DUNCAN PLACE SUBDIVISION, **RESUBDIVISION OF LOTS 19-28**

APPLICATION NUMBER 16 DATE April 4, 2013

DETAIL SITE PLAN

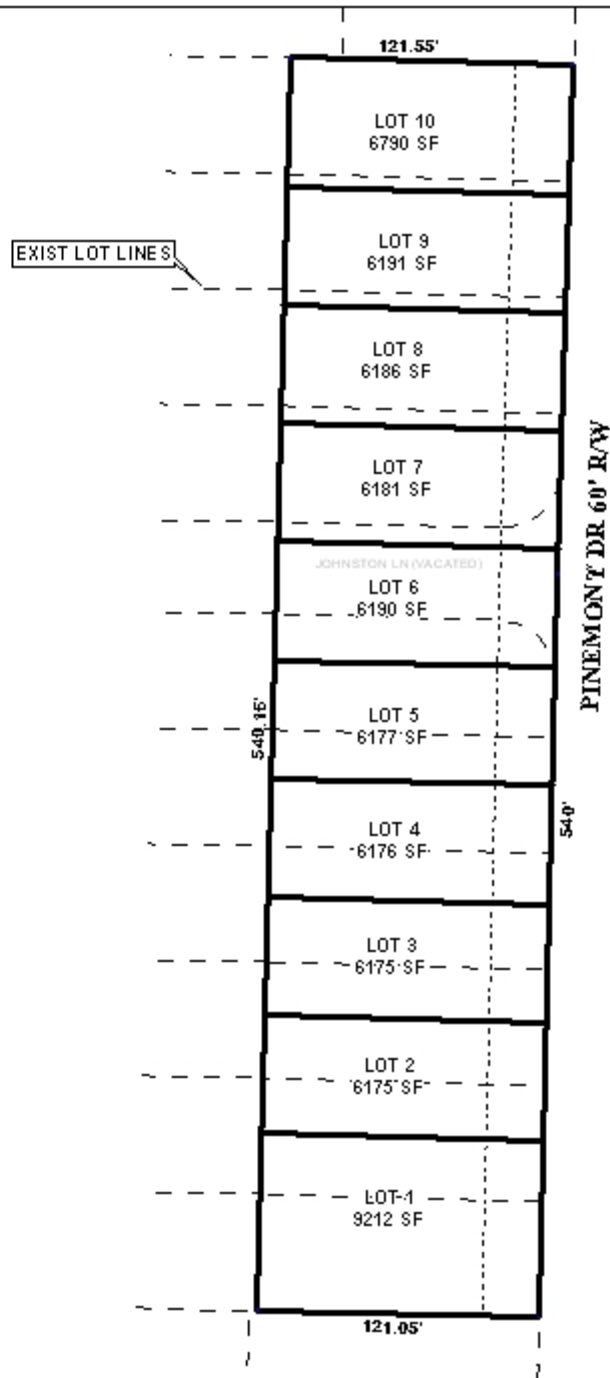
Nine of the Ten proposed lots do not meet the minimum area or width requirements of the Subdivision Regulations, however, they are typical of the Pinehurst neighborhood; and will be larger than the existing lots of record that were approved in 1994. Therefore, a waiver of Section V.D.2 may be considered appropriate. The lot sizes should be retained in square feet and acres on the Final Plat, if approved.

The site has frontage on Pinemont Drive, a minor street with an existing right-of-way width of 60 feet. According to the Subdivision Regulations minor streets without curb and gutter should have a right or way width of 60 feet. The 25 feet setback line is shown and should be maintained on the final plat, if approved.

As a means of access management each lot should be limited to one curb-cut, with the size design or location to be approved by Traffic Engineering and comply with AASHTO standards.

The proposed lots meet the standards for width-to-depth ratio.

- 1) retention of the 25-foot minimum building setback line from Pinemont Drive on the Final Plat;
- 2) placement of a note on the final plat stating that each lot is limited to one (1) curb-cut, with the size, design and location of all curb-cuts to be approved by Traffic Engineering and conform to AASHTO standards;

- 3) the lot sizes in acreage and square feet be retained on the Final Plat;
- 4) compliance with Engineers comments: 1. *Provide all of the required information on the Final Plat (i.e. signature blocks, signatures, certification statements, legal description, required notes).* 2. *Provide a signature block and signature from the Traffic Engineering Department.* 3. *Add a note to the Plat stating that storm water detention will be required for any future addition(s) and/or land disturbing activity in accordance with the Storm Water Management and Flood Control Ordinance (Mobile City Code, Chapter 17 , Ordinance #65-007 & #65-045).*
